G.O., No. 172 M

Hospital Building

Calling for certain information in connection with the ---- at Srivilliputtur.

Municipal hospital at Srivilliputtur

Plan
Hospital & surroundings
...liputtur

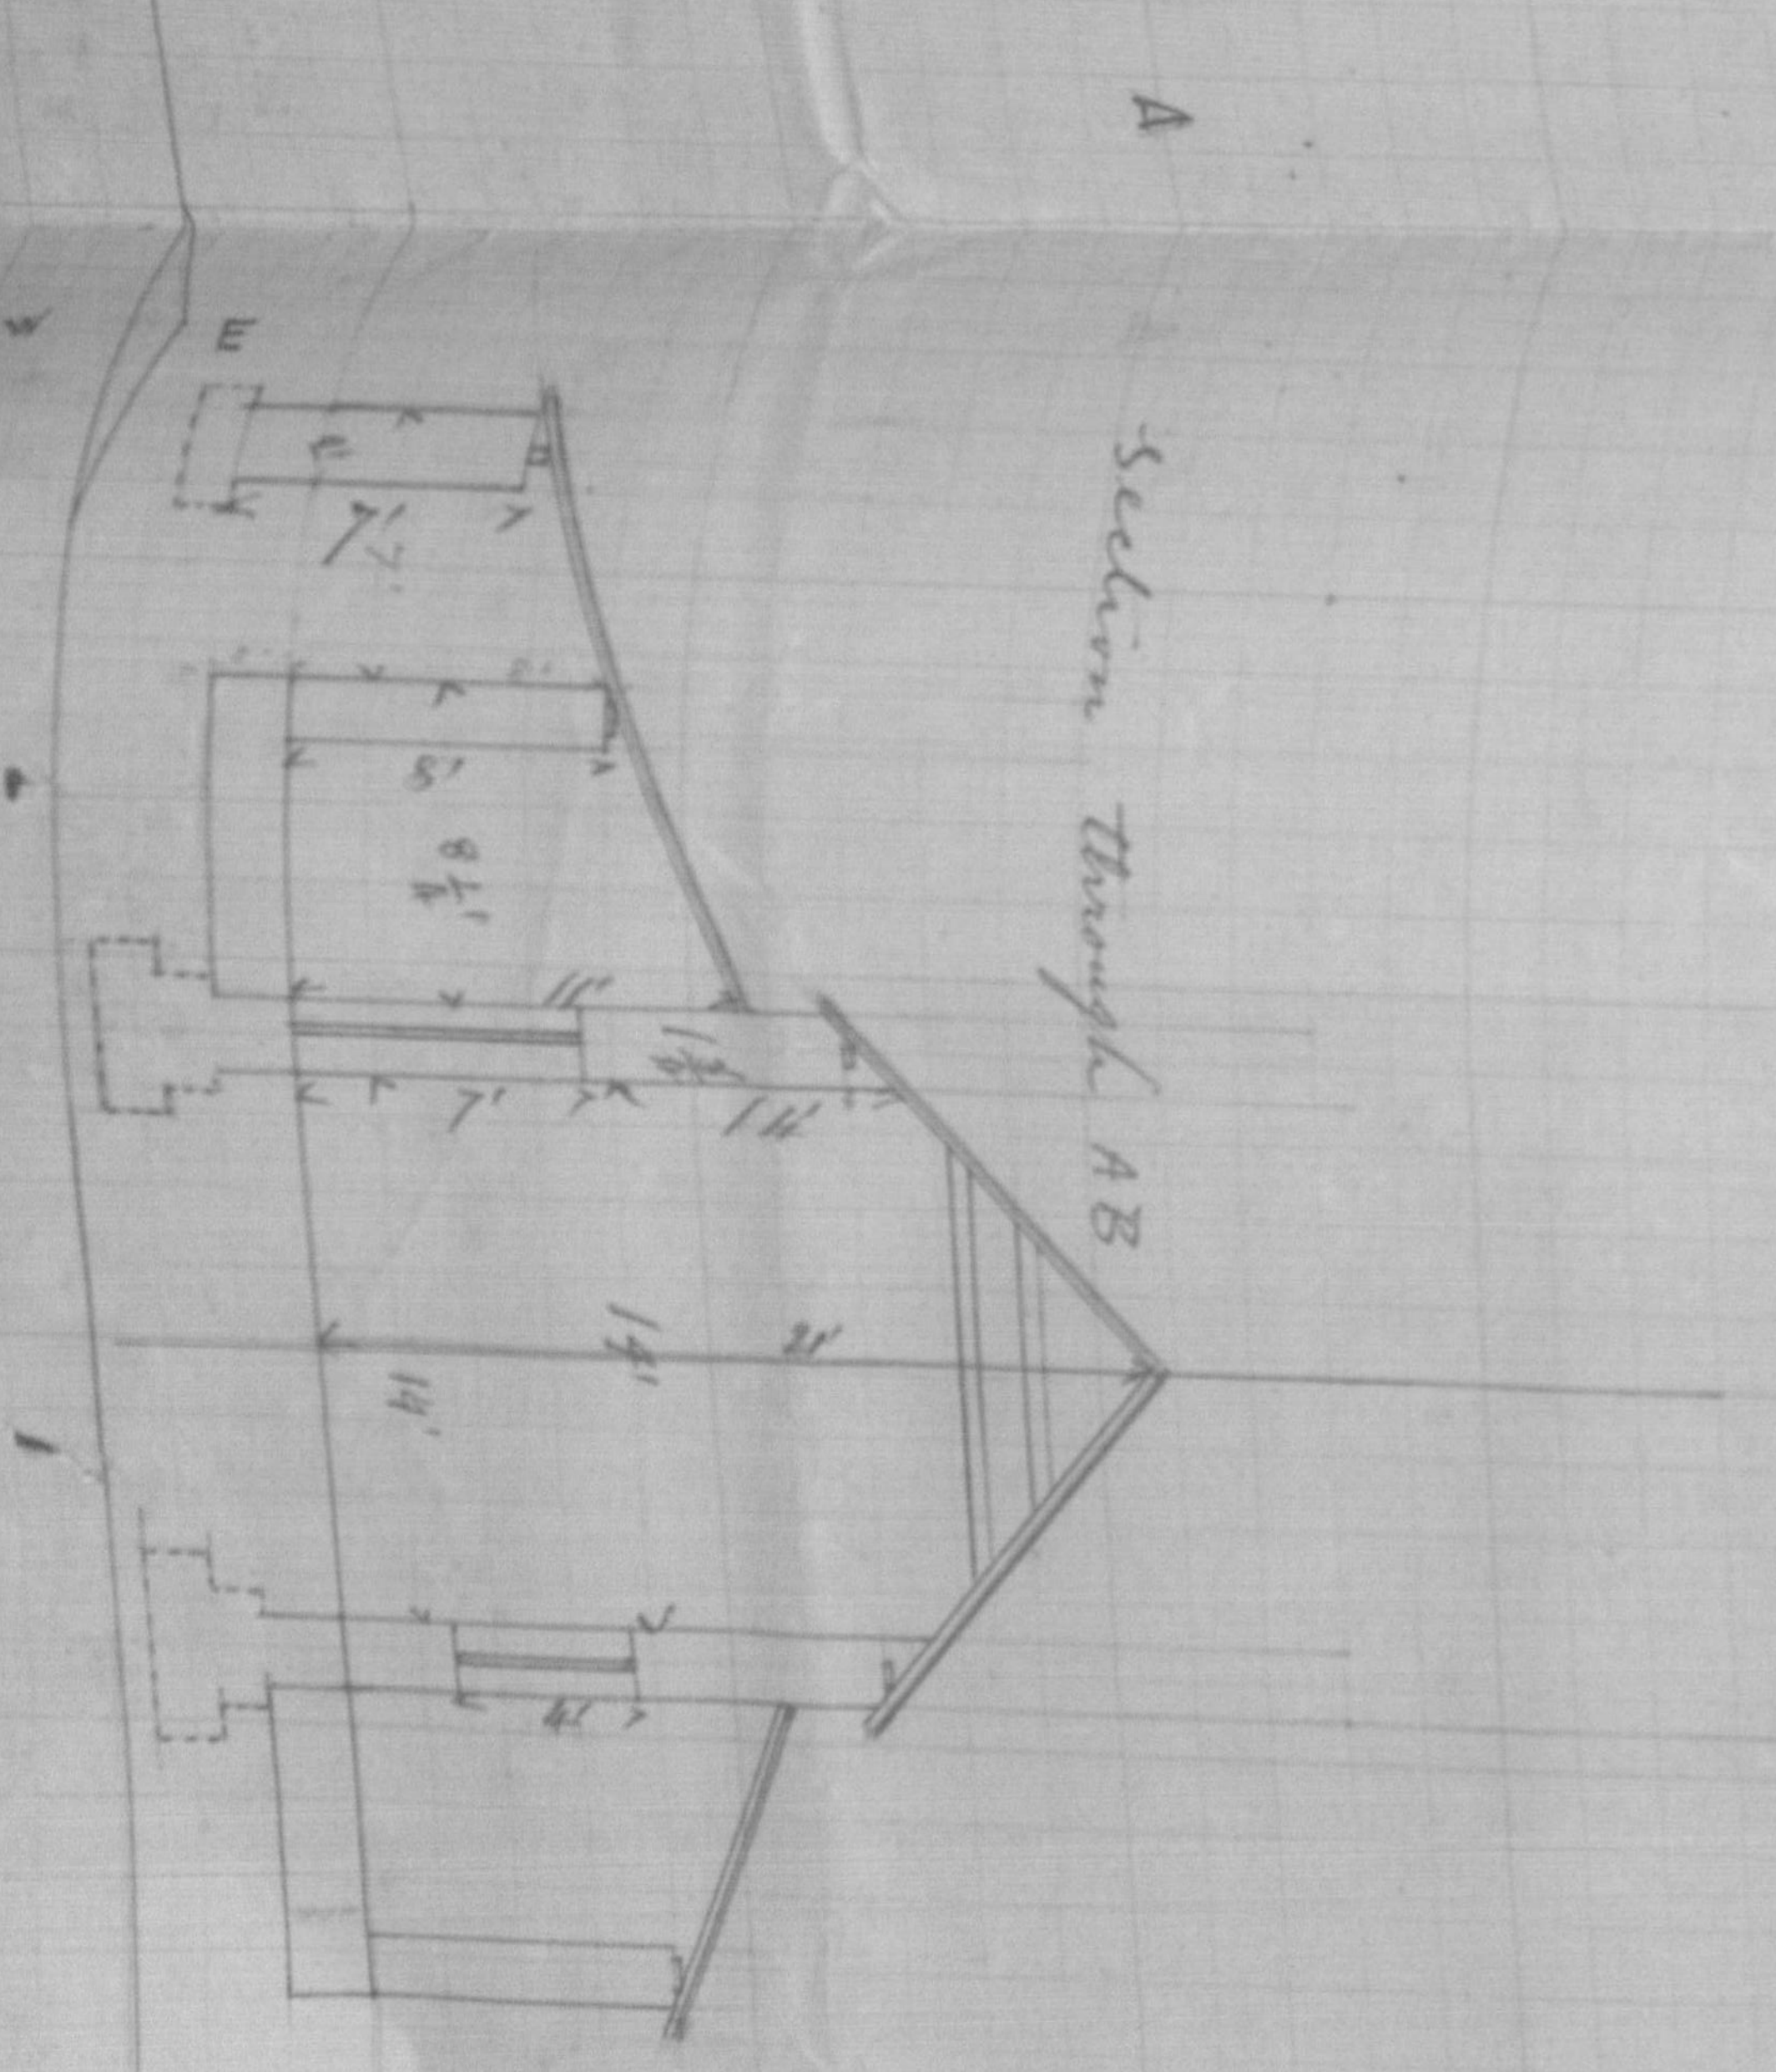
Extent. The hospital compound measures, as shown in the plan, 107 feet from north to south and 114 feet from East to west.

2. Boundaries. The hospital is bounded, in the north by a lane leading to the barbers booths and a number of unsightly barbers huts. Past this there are a few butchers' shops, a Mahommedan Mosque, with burial grounds and the general and fish markets. In the East it is bounded by a road about 15 feet wide joining the Sivakasi road with the north south street of the town

There is another butcher's shop within a distance of 25 feet from the north Eastern End of the hospital and there are a number of unclean Mohommedan huts huddled up to the East of the road and front view of the hospital. The South forms a triangular piece of land bordering on the surplus channel as shown in the plan and having a Mantabam, a place of worship belonging to the Chetties of the town. The West of the hospital Compound is bounded right through by the surplus channel above referred to which is very filthy, the banks of which being largely used by the people for Calls of nature. To the West of the channel, there are crowded houses of Chetties and oil mongers wherefrom the obnoxious smell of the Expressed oils of all sorts mingled with that Emanating from the dried filthy channel is frequently wafted by the westerly wind in and out of season.

of the hospital are altogether unhealthy. The hospital besides being in the midst of unsightly and unclean crowded huts of barbers, Mahommedans and oil-mongers and in close proximity to butchers' shop, fish and general market and Mahommedan burial grounds, is very much shut out from free ventilation and pure air and is situated at the Edge of a filthy channel which is being used as a latrine by the children during the day time and the elderly people in the night time.

4. Accommodation. The hospital, as shown in the plan consists of a main hall, with two verandahs and side rooms and verandahs in front and rear. In the South-Eastern corner of the compound, there is a small hall with a front verandah called "Venereal ward." In the north Eastern corner there is a kitchen and kitchen room, under the same roof. In the South western End of the compound at a distance of only 10 feet from the main building, there is a Post-mortem room. In the north western corner there is a l[illegible] as shown in the plan [illegible]

In conclusion I beg to report that besides the hospital being situated on an unhealthy site with bad and insanitary surroundings and very much shut out, is ill-suited for the purpose of a large hospital which has treated upwards of 26,500 patients this year up to date, as it affords very poor accommodation for In-Patients having no separate wards for male and female patients and no separate dressing rooms for men and women. I beg to add that the compound is too small to accommodate new wards and it is not desirable to have Cholera and other contagious sheds in the midst of the town. Copies of remarks from the visitors' book relating to the hospital [illegible]lding and site are herewith submitted and the proceedings of the Government herewith returned.

2. My opinion is that additional accommodation is required, and that such accommodation cannot be provided on the present site, which, besides being constructed, is unhealthy. I therefore advocate

the construction of a new hospital.
